PROPOSAL FOR DRAFT AMENDMENTS TO REGULATION No. 37

(Filament lamps)

A.1. Alternative specificationAnnex 1.The list of categories of filament lamps and their sheets, amend to read:

CATEGORIES P24W, PX24W, PY24W, PR24W, PS24W, PSX24W, PSY24W and PSR24W

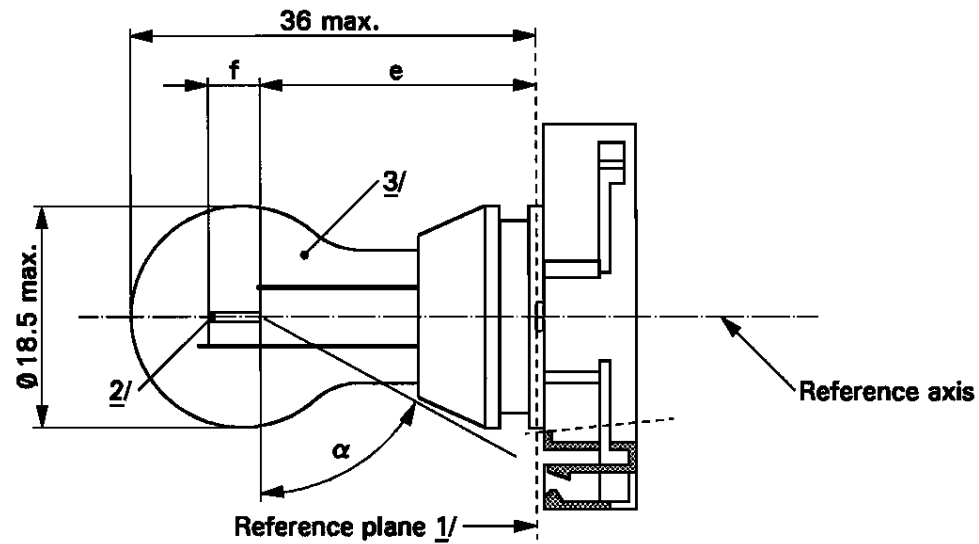
Sheets P24W/1 to P24W/3 (existing), replace by the **new sheets P24W/1 to P24W/3**, to read (see below):

- 1/ The reference plane is defined by the meeting points of the cap-holder fit.
- 2/ No actual filament diameter restrictions apply but the objective is $d \text{ max.} = 1.1 \text{ mm}$.
- 3/ The light emitted from normal production lamps shall be white for categories P24W, **PX24W**, PS24W and **PSX24W**; amber for categories PY24W and PSY24W; red for the categories PR24W and PSR24W.
(See also note 8/)

- 4/ For categories PS24W, **PSX24W**, PSY24W and PSR24W, dimensions shall be checked with O-ring removed.
- 5/ The filament position is checked by means of a "box-system"; sheet P24W/3.
- 6/ The ends of the filament are defined as the points where, when the viewing direction is perpendicular to the plane through the filament lead-in wires as showed in the drawing on sheet P24W/1, the projection of the outside of the end turns crosses the filament axis.
- 7/ No part of the cap beyond the reference plane shall interfere with angle α . The bulb shall be optically distortion free within the angle $2\alpha + 180^\circ$.
- 8/ The light emitted from standard filament lamps shall be white for categories P24W, **PX24W**, PS24W and **PSX24W**; white or amber for categories PY24W and PSY24W; white or red for categories PR24W and PSR24W.

Dimensions in mm		Filament lamps of normal production			Standard filament lamp	
		min.	nom.	max.	<u>8/</u>	
<u>4/</u>						
<u>5/</u> <u>6/</u>			24.0		24.0	
<u>f</u> <u>5/</u> , <u>6/</u>	P24W, PY24W, PR24W, PS24W, PSY24W, PSR24W		4.0		4.0	
	PX24W, PSX24W		4.2		4.2	
<u>α</u> <u>7/</u>	P24W, PY24W, PR24W, PS24W, PSY24W, PSR24W	61.5°			61.5° min.	
	PX24W, PSX24W	58.5°			58.5° min.	
P24W Cap PGU20-3 PX24W Cap PGU20-7 PY24W Cap PGU20-4 PR24W Cap PGU20-6 PS24W Cap PG20-3 PSX24W Cap PG20-7 PSY24W Cap PG20-4 PSR24W Cap PG20-6 in accordance with IEC Publication 60061 (sheet 7004-127-2)						
ELECTRICAL AND PHOTOMETRIC CHARACTERISTICS						
Rated values		Volts	12		12	
		Watts	24		24	
Test voltage		Volts	13.5		13.5	
Objective values		Watts		25 max.		
		Luminous flux	P24W PS24W	500 +10/-20 %		
			PX24W PSX24W	500 +10/- 15 %		
			PY24W PSY24W	300 +15/-25 %		
			PR24W PSR24W	115 +15/-25 %		
Reference luminous flux at approximately			12 V	White: 345 lm

13.5 V	White: 500 lm Amber: 300 lm Red: 115 lm

Screen projection requirements

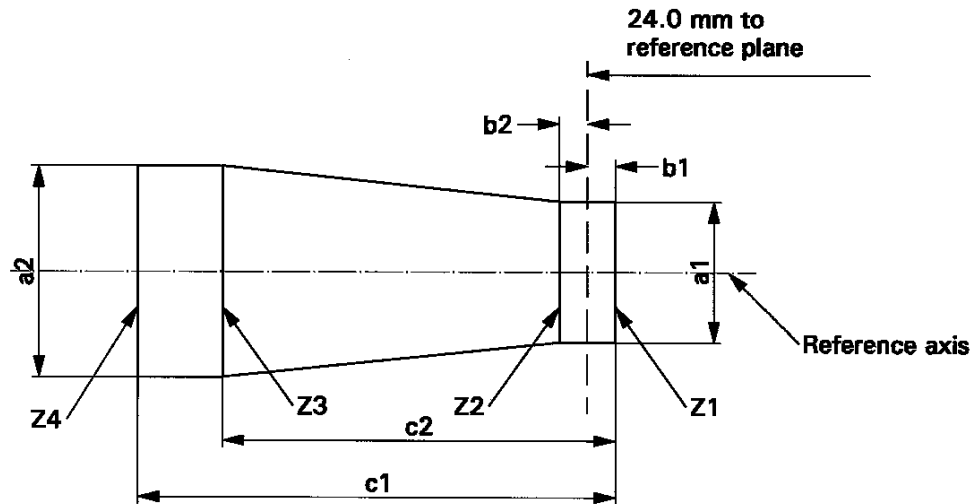
The filament position is checked in two mutually perpendicular planes, one of them being the plane through the lead-in wires.

The ends of the filament as defined on sheet P24W/2, note 6/, shall lie between Z_1 and Z_2 and between the lines Z_3 and Z_4 .

The filament shall lie entirely within the limits shown.

Sheet P24W/3, the table, amend to read:

P24W, PY24W, PR24W, PS24W, PSY24W, PSR24W	a1	a2	b1, b2	c1	c2
Filament lamps of normal production	2.9	3.9	0.5	5.2	3.8
Standard filament lamps	1.5	1.7	0.25	4.7	3.8

PX24W, PSX24W	a1	a2	b1, b2	c1	c2
Filament lamps of normal production	1.9	1.9	0.35	5.0	4.0
Standard filament lamps	1.5	1.5	0.25	4.7	4.0

a1	a2	b1, b2	c1	c2
Filament lamps of normal production	1.9	1.9	0.35	5.0	4.0
Standard filament lamps	1.5	1.5	0.25	4.7	4.0
